ADDENDUM NO. 1 - OUTLINE AND SUMMARY INFORMATION

Project Name: Renne Library Data Center Fire Protection System Upgrades PPA: 20-0036
Location: Montana State University – Bozeman Date: 01/28/2021
Owner: State of Montana, MSU - Bozeman
Plew Building 6th and Grant, PO Box 172760
Bozeman, Montana 59717-2760

RENNE LIBRARY
DATA CENTER - FIRE PROTECTION UPGRADES

1 BASEMENT FLOOR - FIRE ALARM PLAN
FA1.0 1/8" = 1'-0"

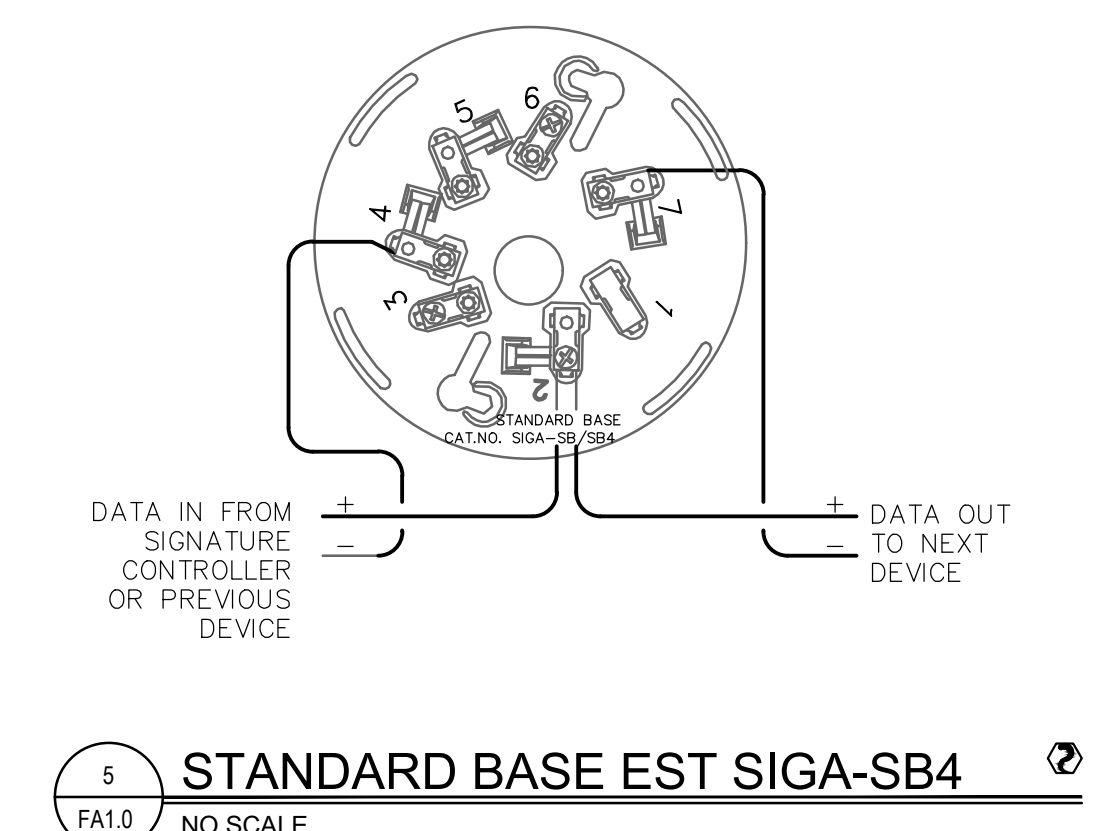
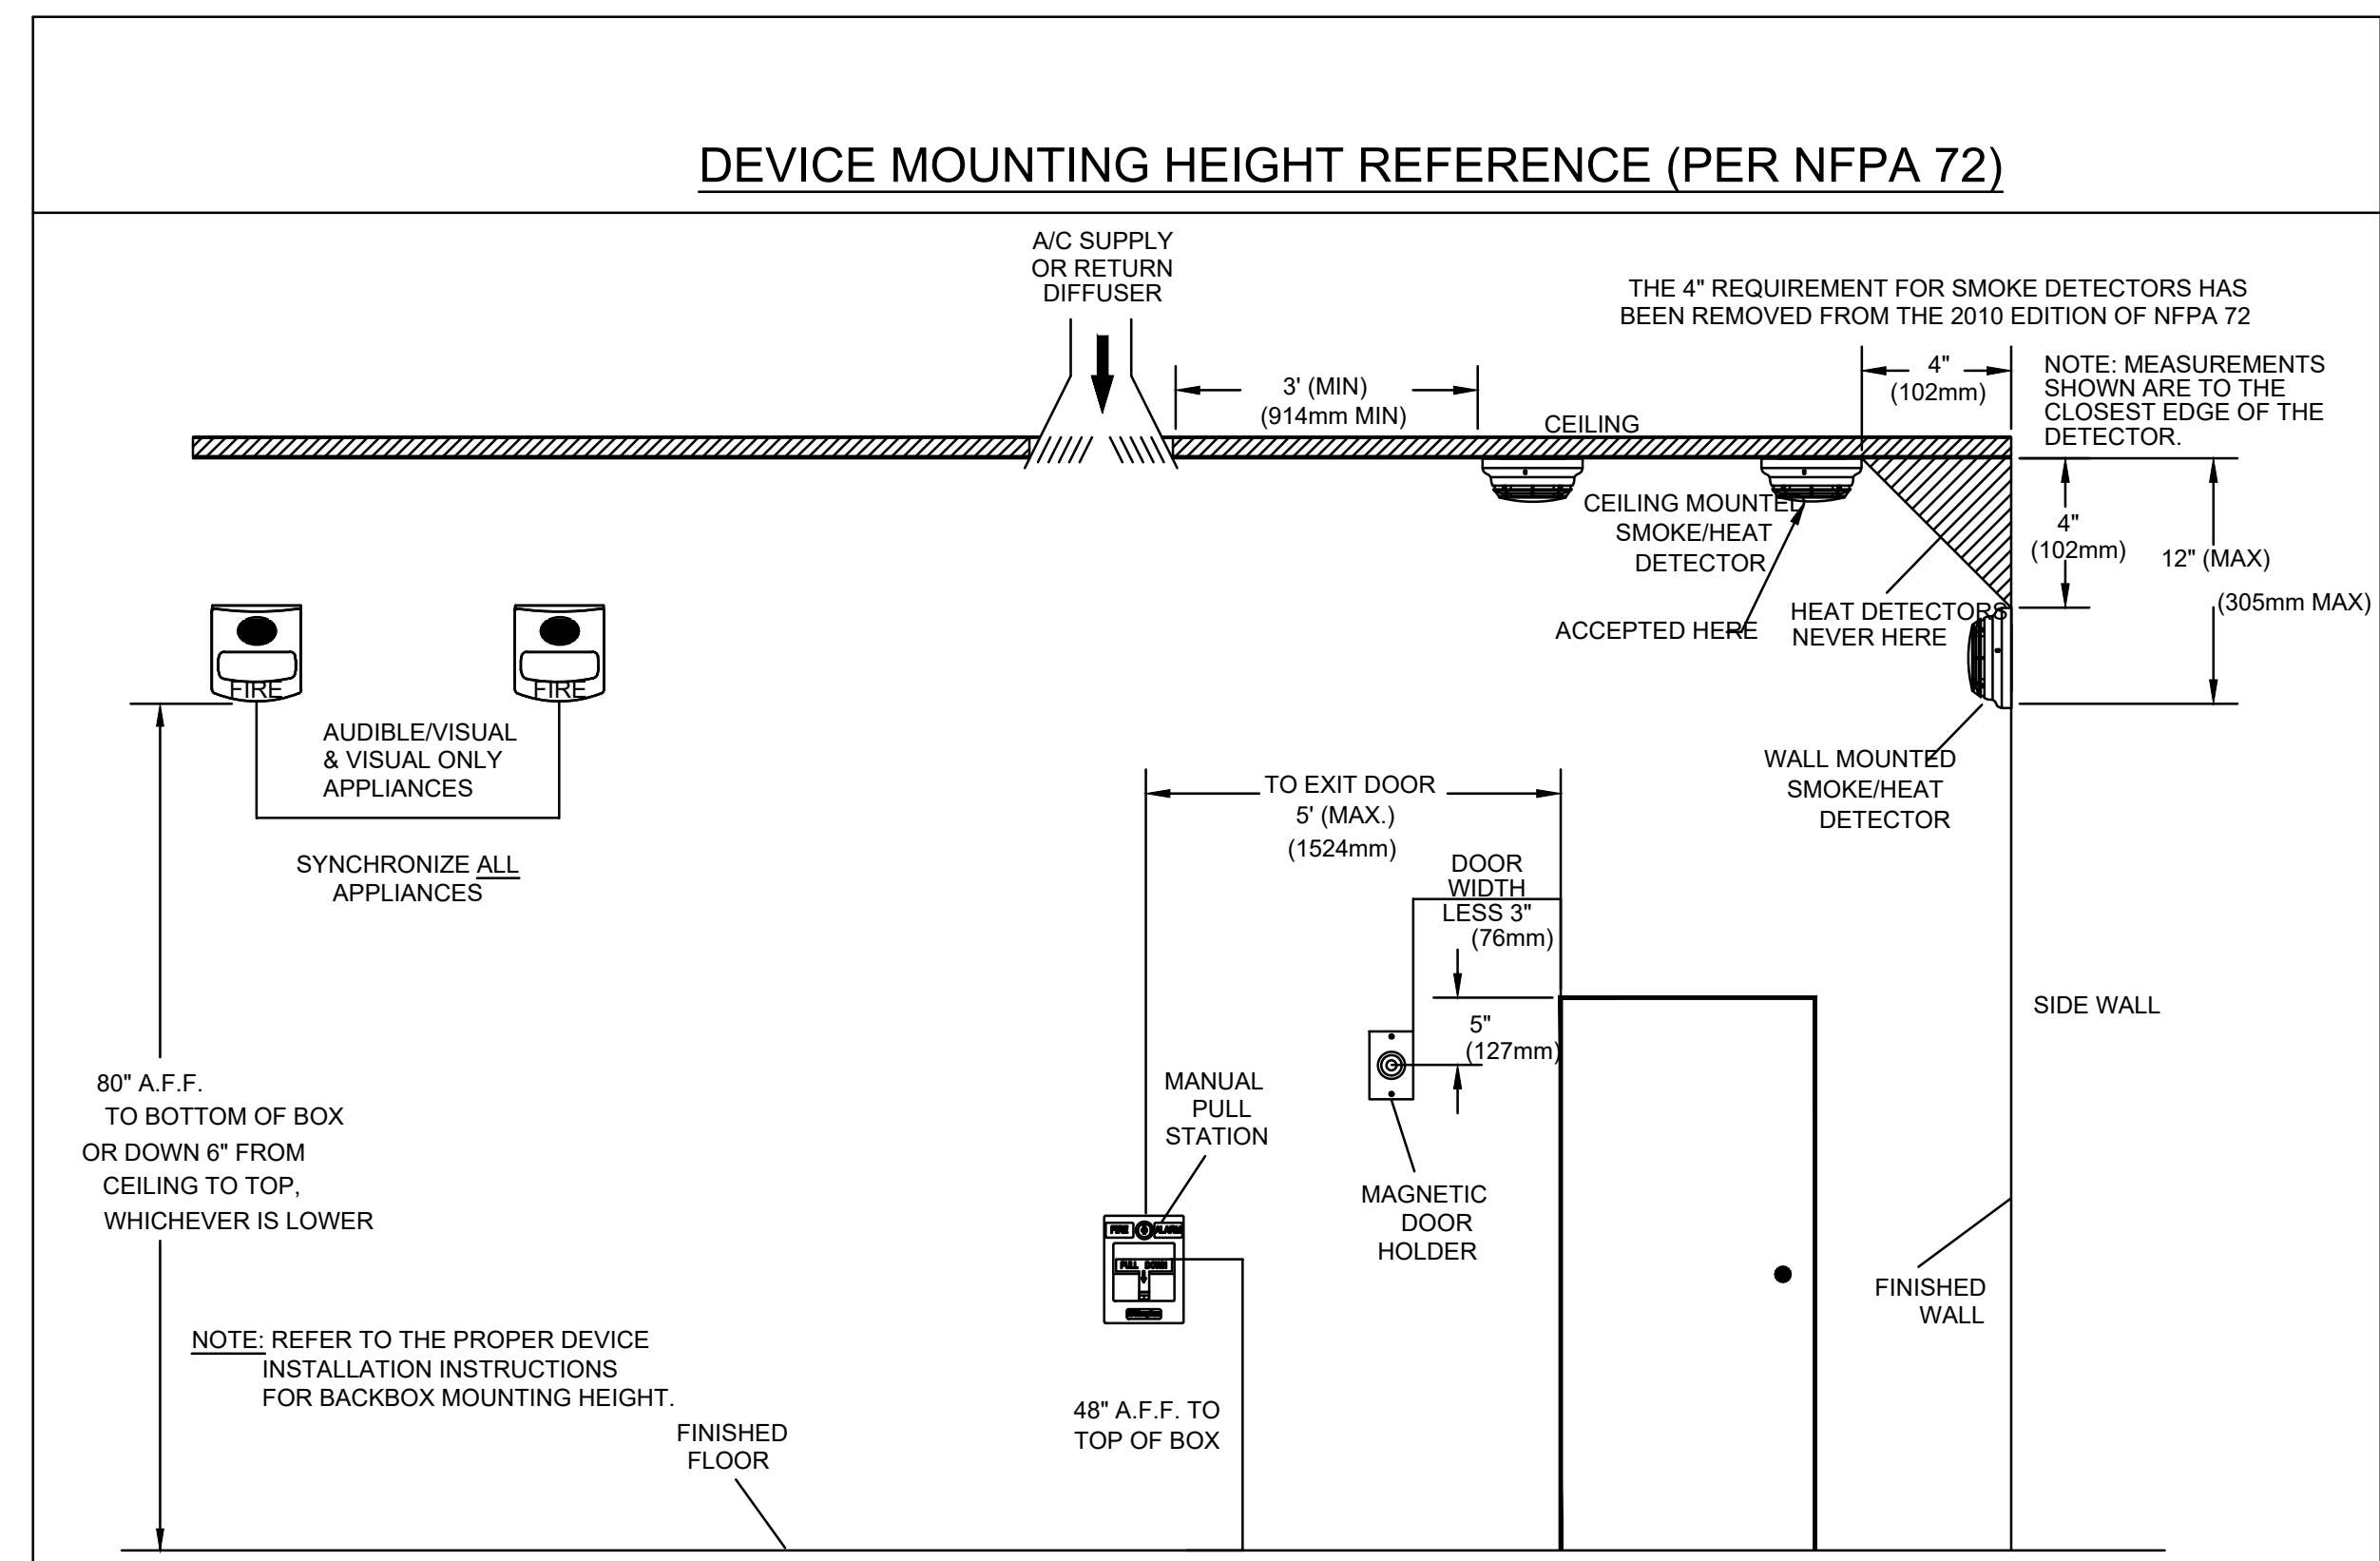
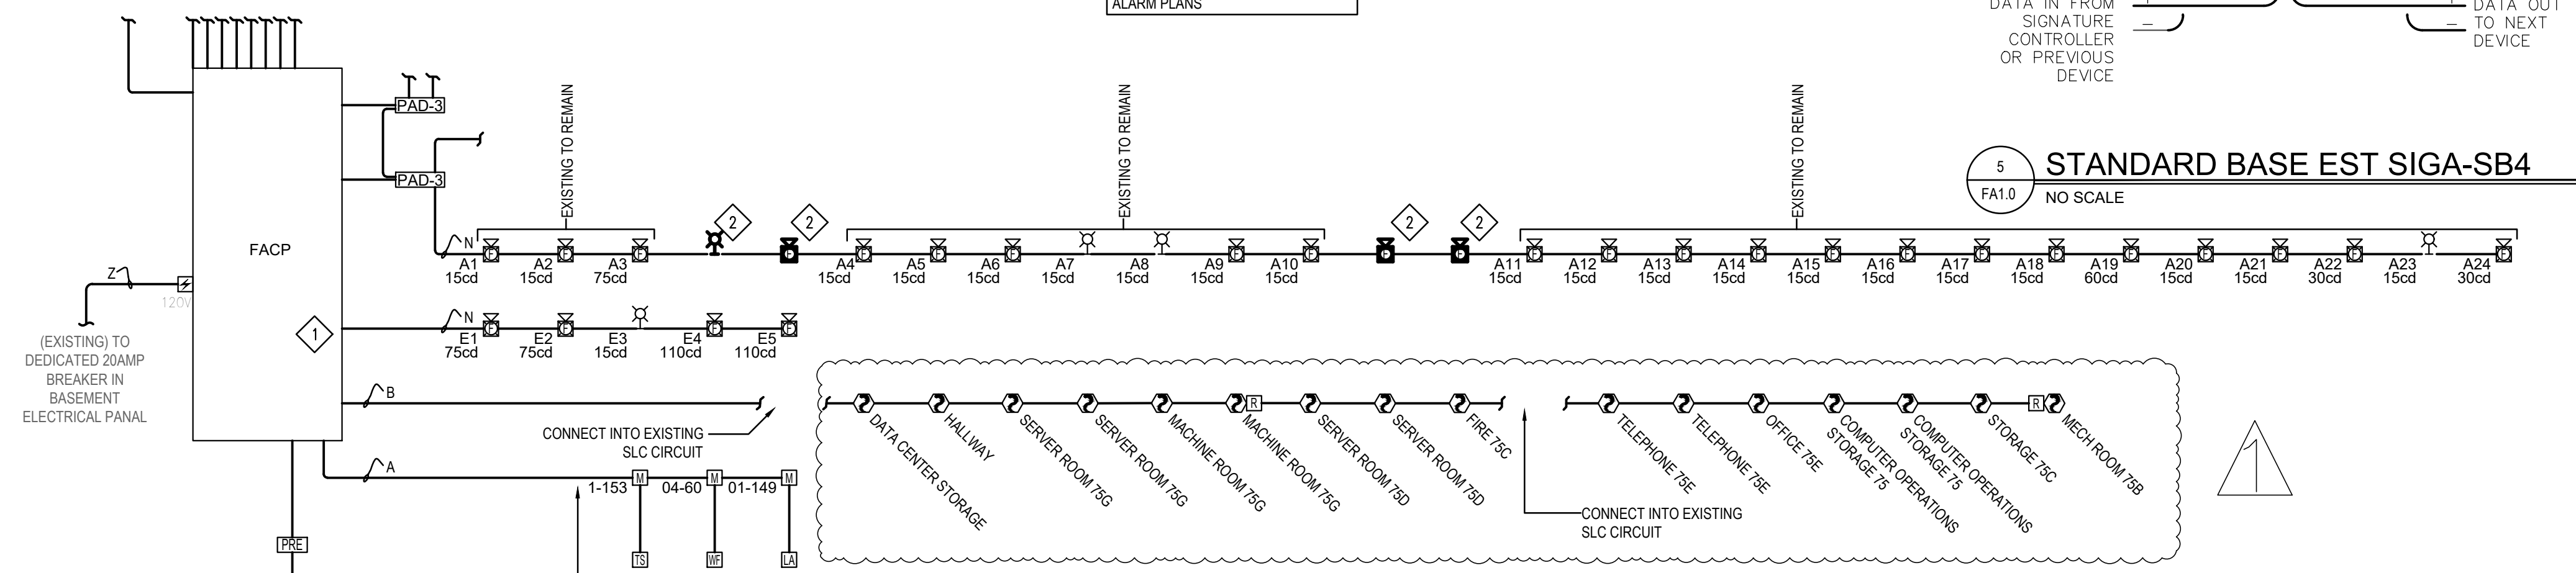
- d. As indicated in the revised drawings noted in Section 2 above, the detection for the pre-action system release has been changed from heat detection to smoke detection. Relays have also been added for shutdown of the cooling units in the data center upon activation of the area smoke detection.

SHEET
FX0.2

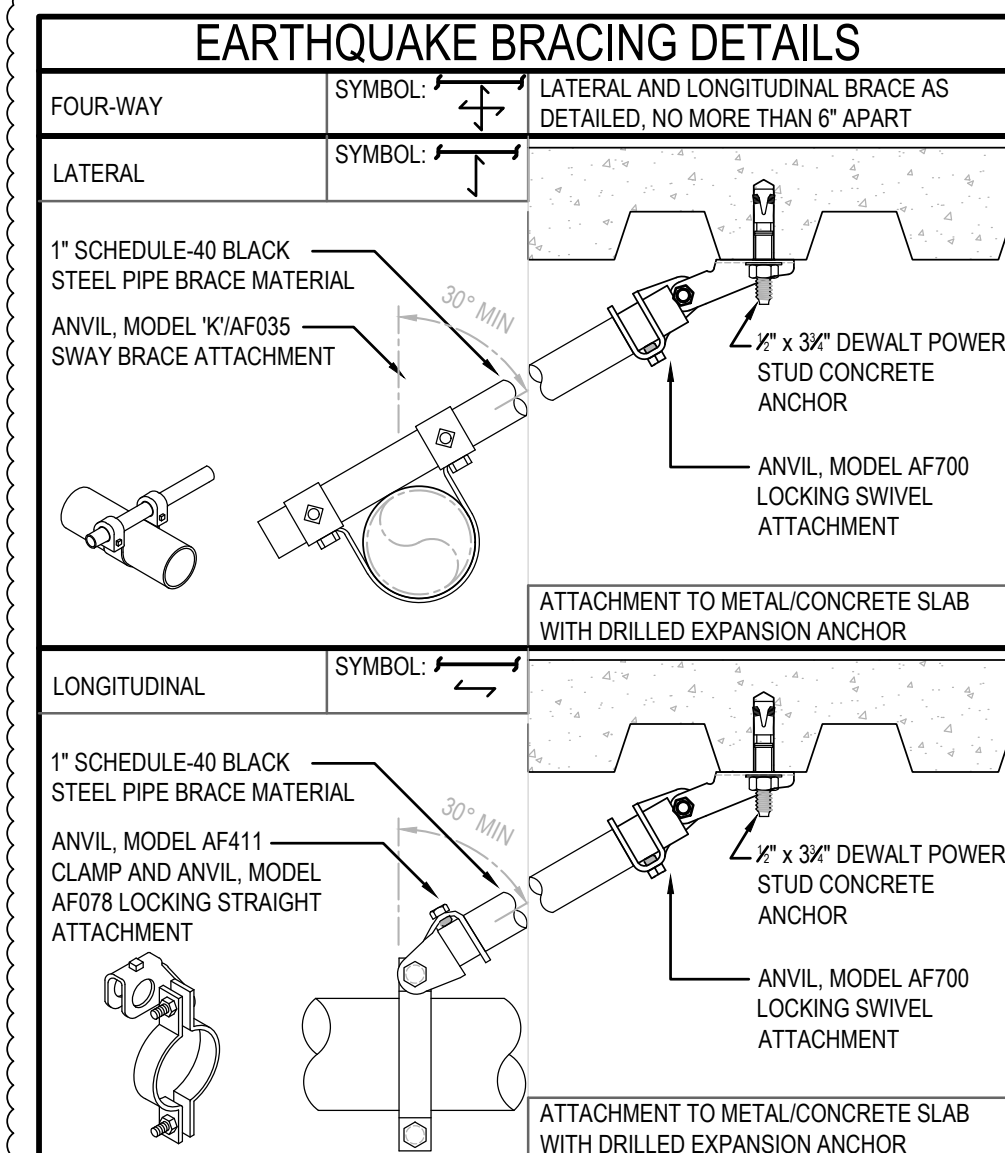
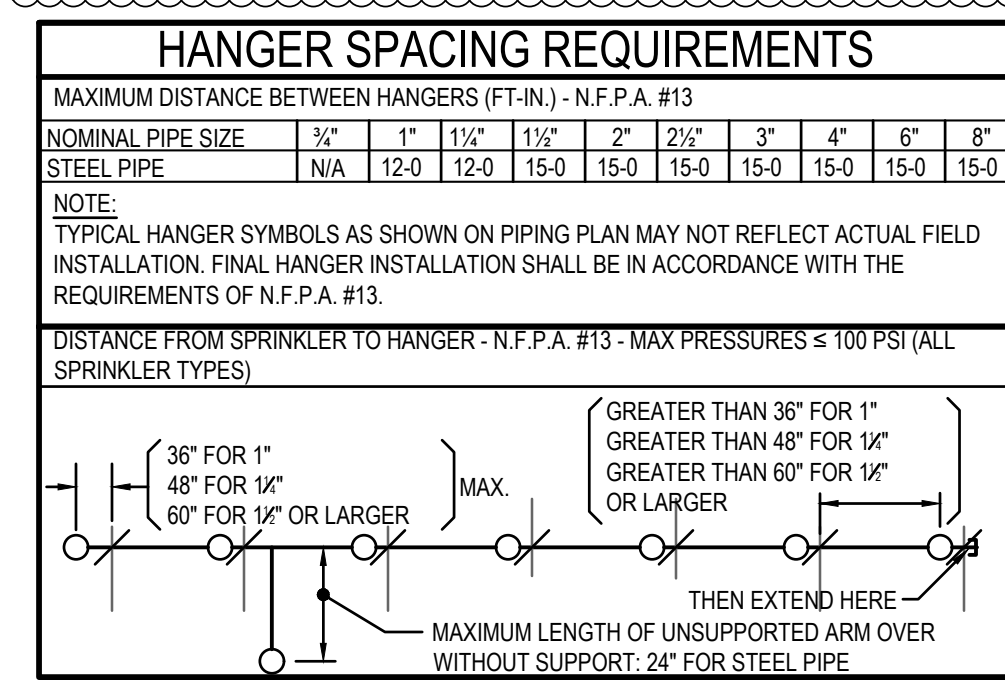
- e. Seismic Details have been updated on drawing FX0.2 to reflect a change from the Hilit TZ Wedge Anchor to the Dewalt Power Stud Wedge Anchor to match Seismic Calculations. Contractor may submit other similar anchors for approval as indicated in the specifications.
